Construction Division
Additions & Alteration Charges Approval Form

Company Name:	Modi Properties Pvt Ltd	Site	May Flower Platinum
Name of the customer	Mr. Pantam Sridhar		
Villa/ Flat No.	A-308		
Sl.No	Description	Amount	
1	Total extra Charges	11,730=00	
2	Total refundable amount	5,760=00	
3	Net amount to be charges (if any)	5,970=00	
4	Net amount to be refunded (if any)		
Remarks:			
Approved by Project Manager	Approved by Design Team	Approved by MD	
Date 16/8/2021	Date	Date	
Sign: 	Sign:	Sign:

Quality Control Check Report.

Details of Additions & Alterations

A8

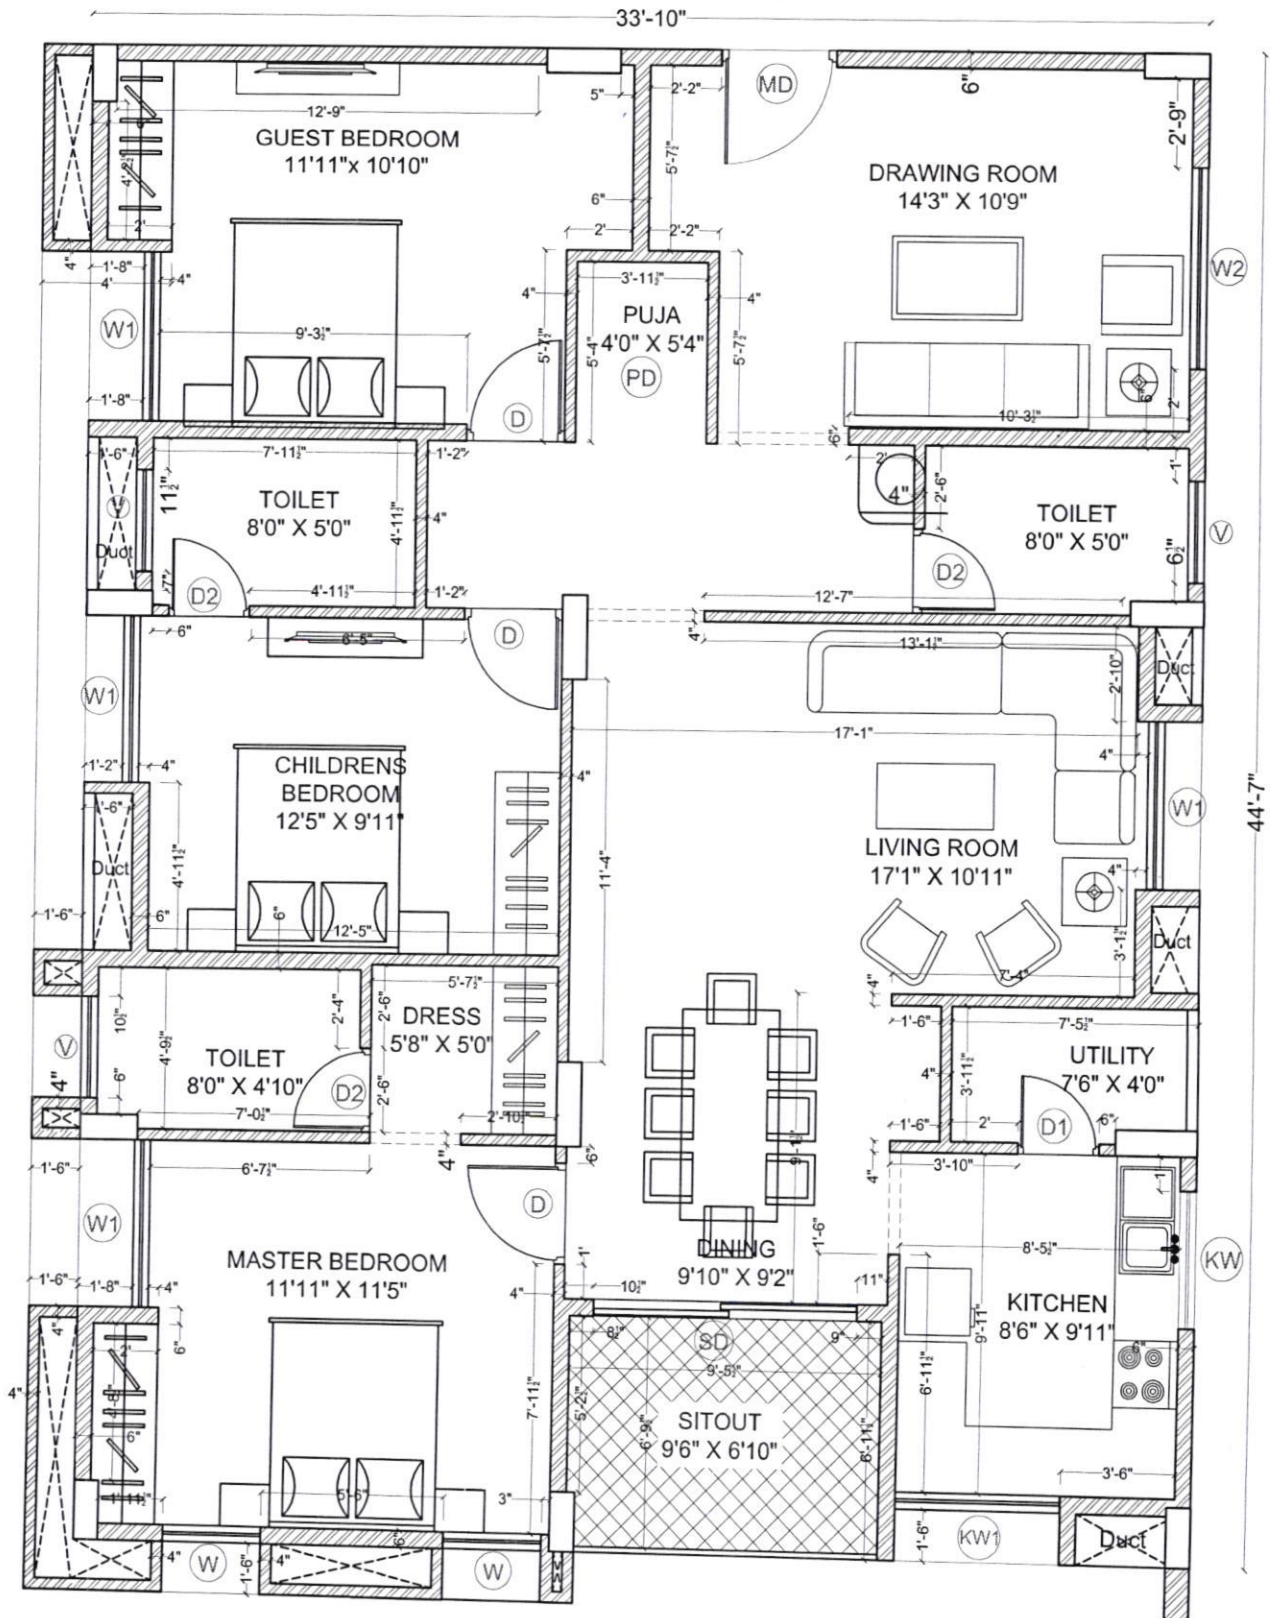
1. Alteration of pooja Room in the hall.

Removal of pooja Room and extending the hall wall.
in the Guest bed room.

2 Hall wall should be equal to utility wall (Drawing)

3. Kitchen ~~tile above the platform~~ flooring we want
to be replaced with floor tile of the flat. 2'x2'

4. Windows to be changed to 3 track ie with mosquito mesh.

Drawing room, ~~and master bedroom~~ ^{Living room and Kitchen.} not required.
6x4 ~~3x4x2 nos.~~

ELECTRICAL PLAN OF FLAT-A8

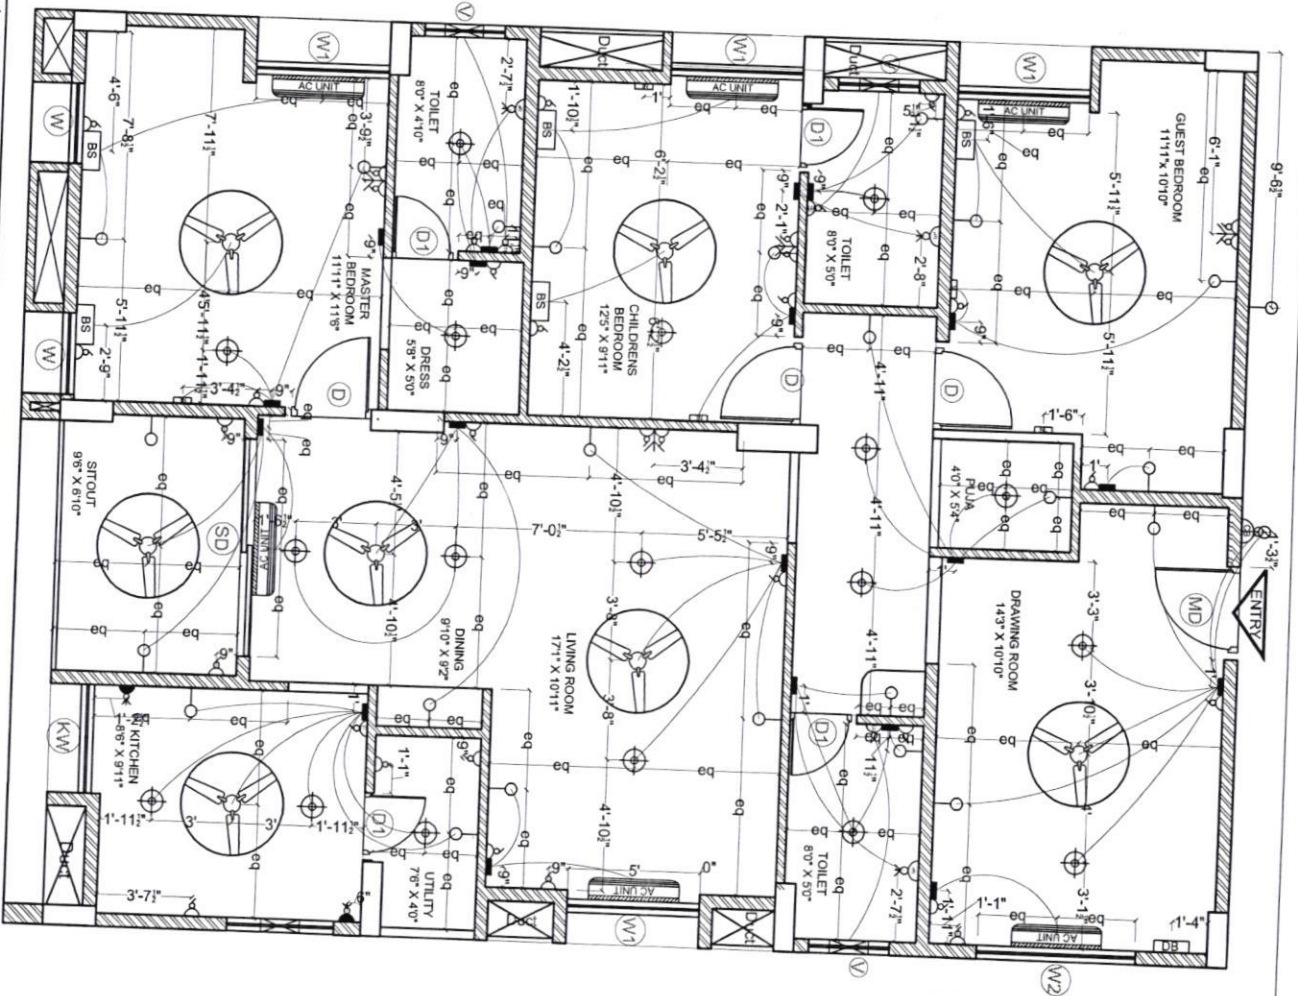
Changes in electrical points: (mark on plan)

1. Kitchen platform: Electrical point back side of the stove to be moved aside or to the corner.
